Access Compliance Report Public Rights-of-Way (Curb Ramps)

Main Street: RANCHO_SANTIAGO_BLV D Cross Street: E_CHAPMAN_AVE Location: NE

ADA ID: RPAT210929105021 Ramp Type: Type 4 - Parallel Initial Pass/Fail: Fail Overall Compliance: No Severity Score: 15

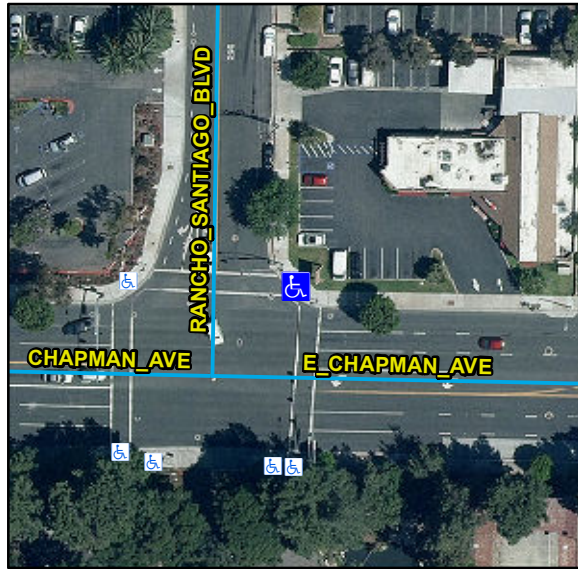
Compliance	Description	Data	Compliance	Description	Data
N/A	Ramp Length LT (in)	23	N/A	Ramp Length RT (in)	45
Yes	Ramp Width LT (in)	65	Yes	Ramp Width RT (in)	67
Yes	Ramp Run Slope LT (%)	4.1	No	Ramp Run Slope RT (%)	9.2
Yes	Ramp Cross Slope LT (%)	1.5	Yes	Ramp Cross Slope RT (%)	1.9
N/A	Landing Present	N/A	N/A	DWS Provided	N/A
N/A	Landing Length (in)	N/A	N/A	DWS Contrast	N/A
N/A	Landing Width (in)	N/A	N/A	DWS Length (in)	N/A
N/A	Landing Run Slope (%)	N/A	N/A	DWS Full Width	N/A
N/A	Landing Cross Slope (%)	N/A		DWS Offset Type	N/A
N/A	Landing Movement Obstructed?	N/A	N/A	DWS Offset Left (in)	N/A
	Landing Movement Type	N/A	N/A	DWS Offset Right (in)	N/A
N/A	Landing Shared	N/A			
N/A	Clear Space	Yes			
N/A	Clear Space To Crosswalk (in)	48			
N/A	Marked Crosswalk 1	Yes	N/A	Marked Crosswalk 2	Yes
	Crossing 1 Direction	W		Crossing 2 Direction	S
	Marked Crosswalk 1 Width (in)	120		Marked Crosswalk 2 Width (in)	120

Remove & Replace Curb Ramp With Two New Directional Ramps or Equivalent.

R304.3.2, STD 1115
